**Re: Bradford Mesa Quarry, Permit No. M-2019-046, Technical Revision (TR-1),
Adequacy Review-4**

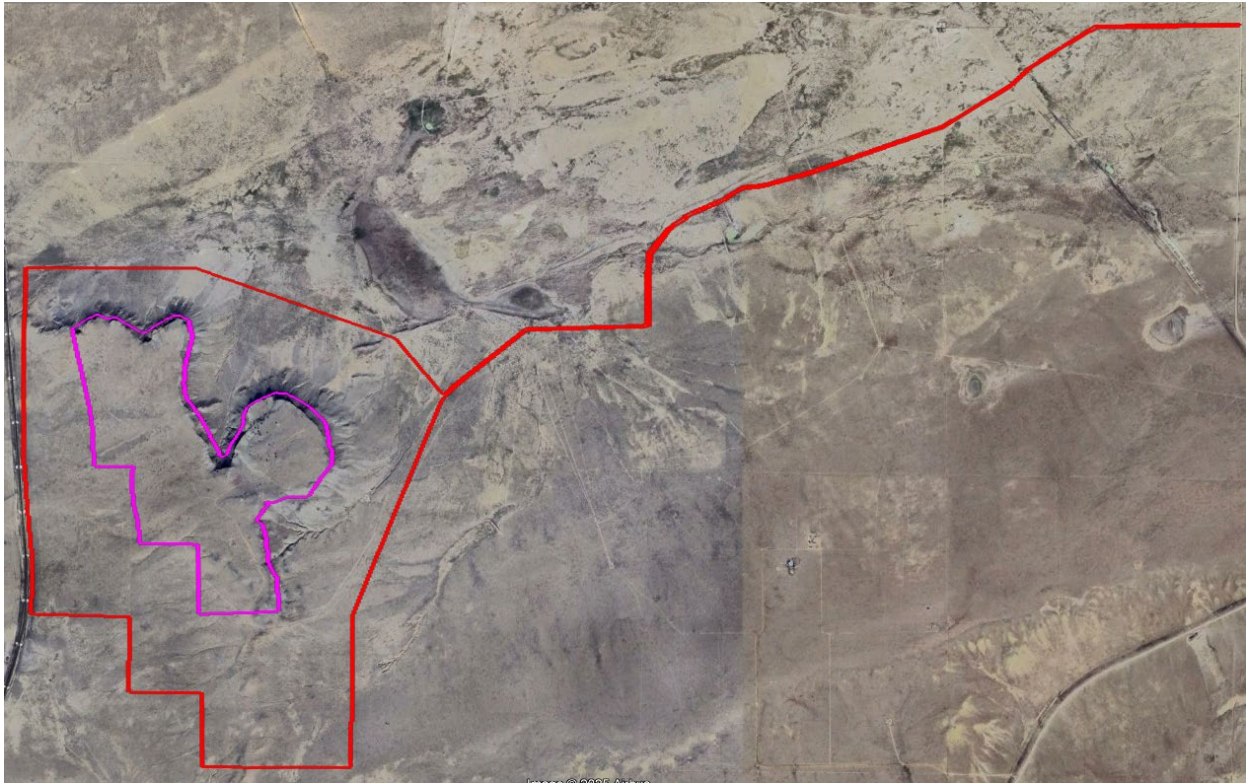
- ✚ **The following item has not been addressed thoroughly from the Division's Third Adequacy Review.** Through using the Applicant's Landowner Map Exhibit C.1 as an overlay, it appears that the mining area depicted by the phase boundary on the map only equates to approximately 282 acres (see Figure 1 below). The Applicant stated within the narrative that the area to be mined and reclaimed consists of 569.1 acres. The Applicant states that an additional 16 acres will be disturbed for the haul road but will remain in place after reclamation. Please address and respond to item 1 below to explain and/or correct the acreage discrepancies.

1. The Applicant has provided a new mining plan map with new phases. The site is currently permitted to affect a total of 569.1 acres.
 - (a) Please revise the map to clearly mark the entirety of the affected land boundary and ensure it equals 569.1 acres within the currently approved affected area. If the affected area is proposed to be reduced, an acreage reduction revision must occur prior to the approval of this TR.
 - (b) Please update the Mining Plan and Reclamation Plan narratives to describe the total affected acres proposed through the TR1, including acres for the haul road, phased mining areas, processing areas if separate from mining areas, etc.
 - (c) Please also update the Exhibit L narrative to reflect the above acreage descriptions (see the screenshot from the last adequacy review and the currently approved Exhibit L below).
